Mar 9th 2017

「MCGS-Ø63 TWIN-GUIDE CYLINDER」 Body Appearance Change Notification

Comparison	
Before	After

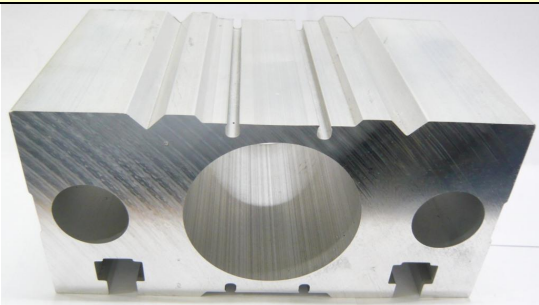
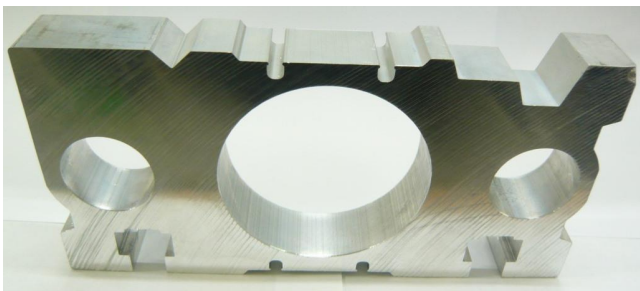
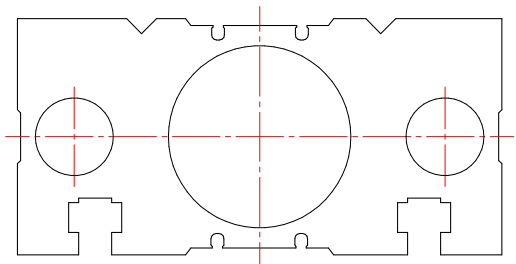
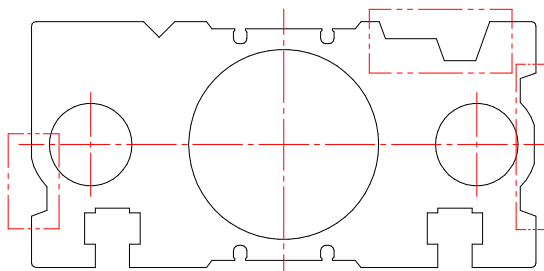
Changing the body appearance and the comparison is as followed:

2D drawing before change.	2D drawing after change. (Differences are as specified.)
